PROJECT: SP-1441-00(008)/110008301 - Hinds

SPECIAL PROVISION NO. 907-413-3

SUBJECT: Cleaning and Sealing Joints and Cracks

PROJECT: SP-1441-00(008) / 110008301 – Hinds County

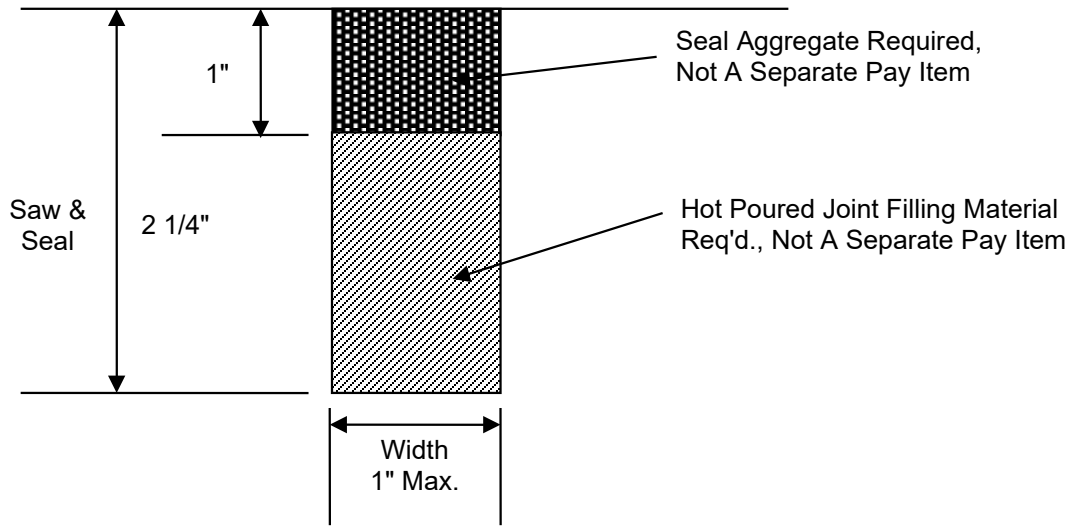
907-413.02--Materials. After the third paragraph of Subsection 413.02 on page 329, add the following.

Material for filling joints and cracks greater than 1” shall be a mastic patching material manufactured by one of the following:

JOINT AND CRACK CLEANING AND FILLING DETAIL FOR PAVEMENTS WITH EXISTING ASPHALT OVERLAY

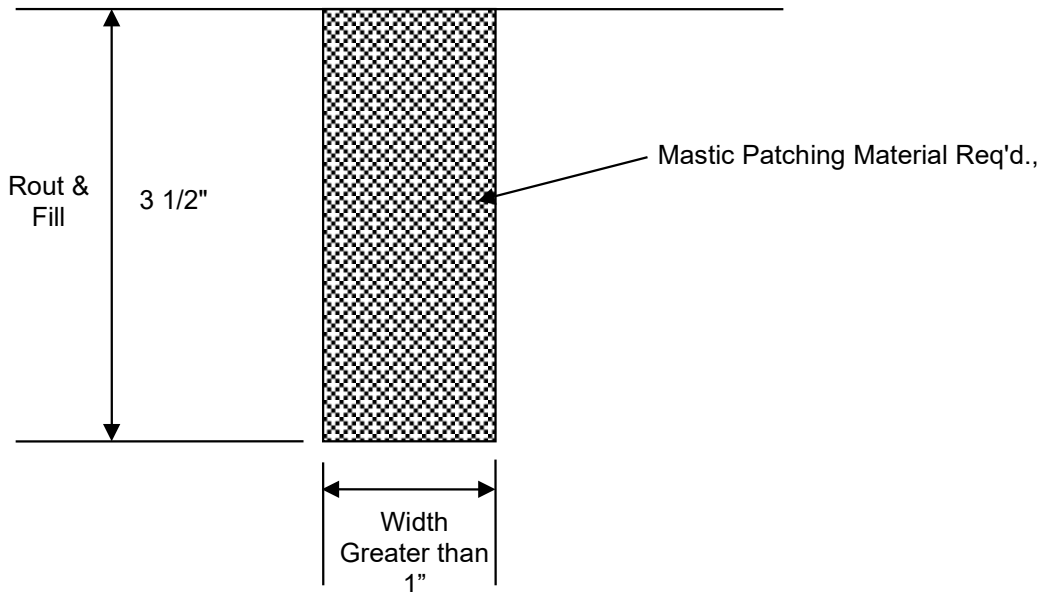
907-413.03.4--Cleaning and Filling Joints. Delete the Details in Subsection 413.03.4 on page 334, and substitute the following.

Variable Depth Asphalt -- Remove as necessary to expose joint

Variable Depth Asphalt—Remove as necessary to expose joint
